## HISTORIC AND DESIGN REVIEW COMMISSION

**HDRC CASE NO:** 2017-132  
**ADDRESS:** 115 S ZARZAMORA  
**LEGAL DESCRIPTION:** NCB 2322 BLK 1 LOT 7&8 AND 9  
**ZONING:** C-2,HL  
**CITY COUNCIL DIST.:** 5  
**LANDMARK:** Malt House  
**APPLICANT:** Kaufman Killen  
**OWNER:** 7-Eleven Inc.  
**TYPE OF WORK:** Conceptual Review of Replacement Plans  
**REQUEST:**

The applicant is requesting conceptual review of replacement plans on the property at 115 S Zarzamora. The applicant is proposing to construct a new commercial structure on the property including attached canopies, fuel pumps, and signage.

SITE PLAN

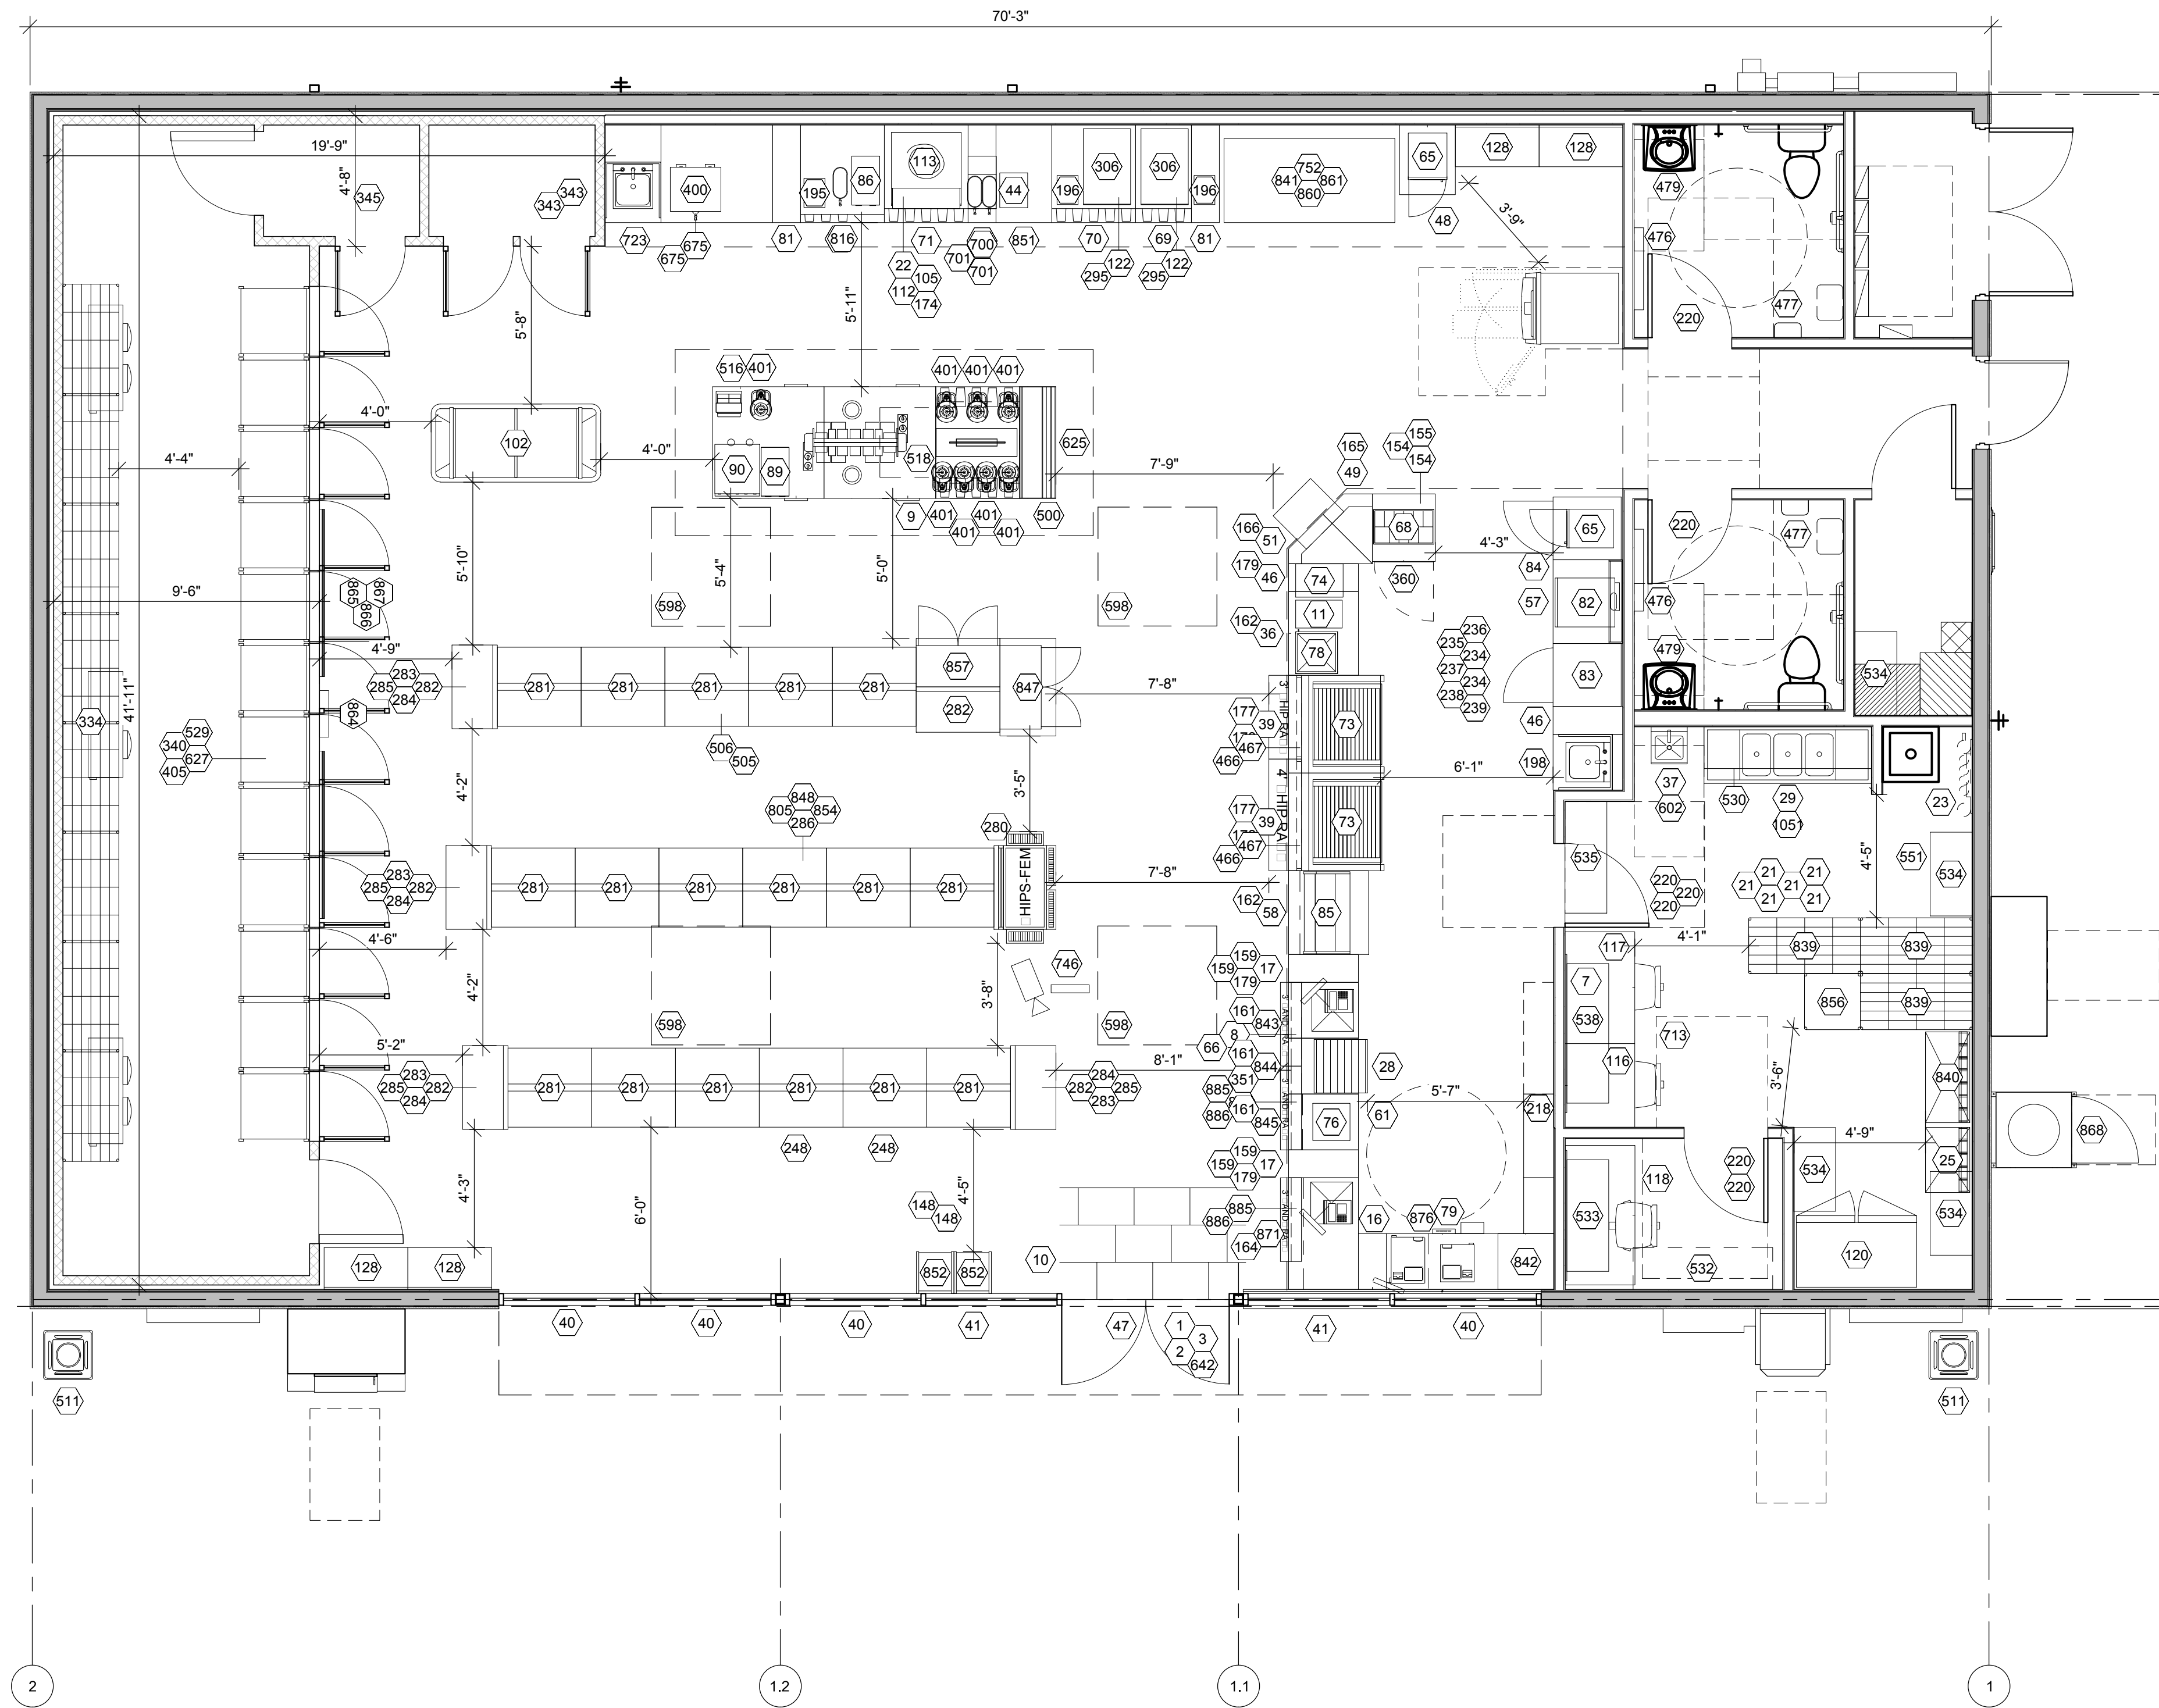
- l. **ORIENTATION OF PRIMARY FACADE** - The existing building is situated on the north end of the property and faces south. This allows for exposure from the street corner. The proposed replacement building is situated on the east end of the property with the primary entrance facing west toward the interior of the lot. Consistent with the established spatial relationships of the site, the orientation and placement of the existing building should be maintained in the replacement plans. It was previously recommended at the Design Review Committee on September 14, 2016, that there be a pedestrian entrance along Zarzamora and Buena Vista and that all street elevations include windows. While windows have been added to the rear elevation that faces Zarzamora, the proposed façade orientation limits pedestrian access to the property and leaves the rear of the building to face the primary street. The proposed replacement plans are not consistent in terms of façade orientation and building placement. Even if the building placement is approved, the street facing facades should be activated.

- m. **SITE PLAN AND BUILDING PLACEMENT** - As noted in finding l, the existing building is situated on the north end of the property and faces south. The primary entrance is visible from the corner, and the canopies are the central feature of the site. This established pattern is an important characteristic of the property. The applicant has stated that site constraints restrict the placement of the commercial building and canopy in a similar pattern as the existing building and canopies. It has been discussed at previous meetings that other 7-Eleven stores feature site plans with similar building placement to the existing structure on site. A store at the corner of Babcock and Wurzbach is provided as an example in the exhibits for this request. This property measures approximately 180 ft x 180 ft. The property at 115 S Zarzamora measures approximately 155 ft x 155 ft. Given the similarity in the two sites, staff finds that the overall building placement and orientation can continue to be explored by the applicant. The applicant has shown in plan that fuel trucks would not have sufficient room if the existing pattern were to be maintained. In these explorations, only the main structure has been moved leaving the fuel tanks and pumps in the original location. These exhibits also only explore fuel truck access from one direction. Staff finds that additional exploration and creativity is warranted. Additional explorations should include potential locations and arrangements of not only the commercial structure, but also the fuel tanks and seating area. If this analysis has occurred, the applicant should submit that evidence for consideration.

- t. **SCREENING** - The applicant is proposing to construct a dumpster enclosure located on the northwest corner of the lot. According to the Guidelines for New Construction 6.A. and B., service areas should be screened from the public right of way. Staff finds the proposed screening consistent with the Guidelines. However, if any other mechanical equipment is needed, the applicant is responsible for complying with the Guidelines and receiving approval for their placement and screening. Additional screening and landscape buffers from the adjacent properties have not been provided.

**COMMENTS/CONCERNS:** Discussed site plan if replaced new building at existing building location. MG: How KR: Questions regarding seen setbacks. MG: Asked about existing setbacks. Asked about truck clearance. KR: Asked about location of canopy in order to allow different location of structure. MG: Concerns about matching existing setback from Zarzamora. KR: Asked about retaining portion of existing walls, to avoid needing a variance. MG: The footprint is what's important. CG: Addition along alleyway could increase alleyway width. Suggested remaining using parking space of Bill's Pawn Shop. Questions about schedule of fuel delivery. Questions of easement. MG: Questions about existing drive. Questions about using ally. Reverse the maneuver of refueling? Questions about rear addition. More testing for the idea of using existing footprint. KR: There are examples of using the skins in San Antonio. MG: more exploration is needed. Suggested examples of propping exterior & build on the inside. → continued to back.

1. That the proposed new construction be constructed at the same setbacks and orientation of the existing structure to maintain spatial relationship
2. That the applicant salvage and reuse both of the historic, roof-mounted "Malt House" signs
3. That a documentation and salvaging strategy be submitted
4. That the applicant explore adding further screening and buffer between the adjacent properties
5. That the applicant provide details of the proposed new signage
